Subject: Foam Guard Panel is available for Kent Champion 28, CarpeTrierer 28, and Nilfisk GU700A and GU700A -60.

Models Affected: CarpeTrierer 28 (115V) (56330020)
Kent Champion 28 (2002 model) (56648330)
Nilfisk GU700A (56330910)
Nilfisk GU700A-60 (56330049)

ECO#: A-04946

Figure 2 – Bag Disconnected from Intake Tube

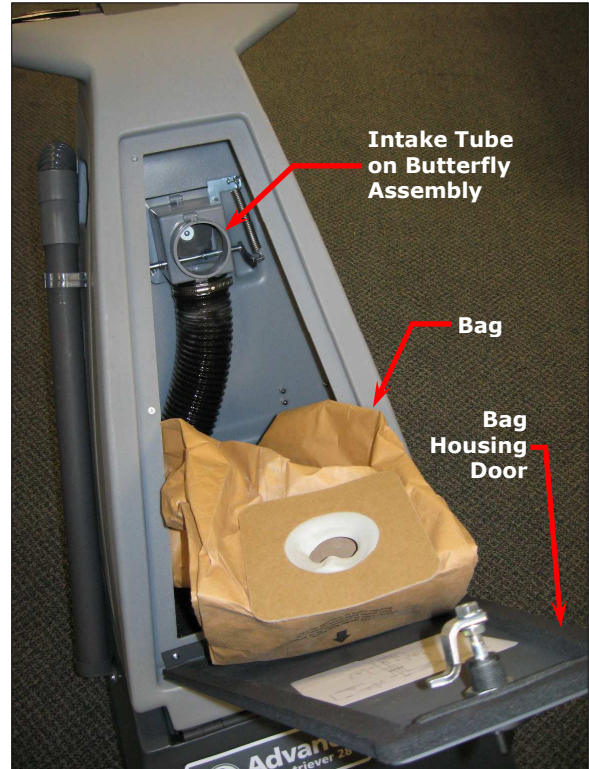
Issue: Tears in paper filter bags have been reported.

Cause: When the paper bag inflates, it can get behind the cardboard panel and contact the arm on the air flap lever when the valve is opened and closed.

Field: If premature failure of the paper dust bag occurs, install the foam Guard Panel as follows:

1. See Figure 2. Open the **Bag Housing Door** and disconnect the **Bag** from the **Intake Tube** on the **Butterfly Assembly**.

2. See Figure 3. Install the foam **Guard Panel** onto the **Butterfly Assembly**.
3. See Figure 2. Reinstall the **Bag** onto the **Intake Tube** on the **Butterfly Assembly**, then close and latch the **Bag Housing Door**.
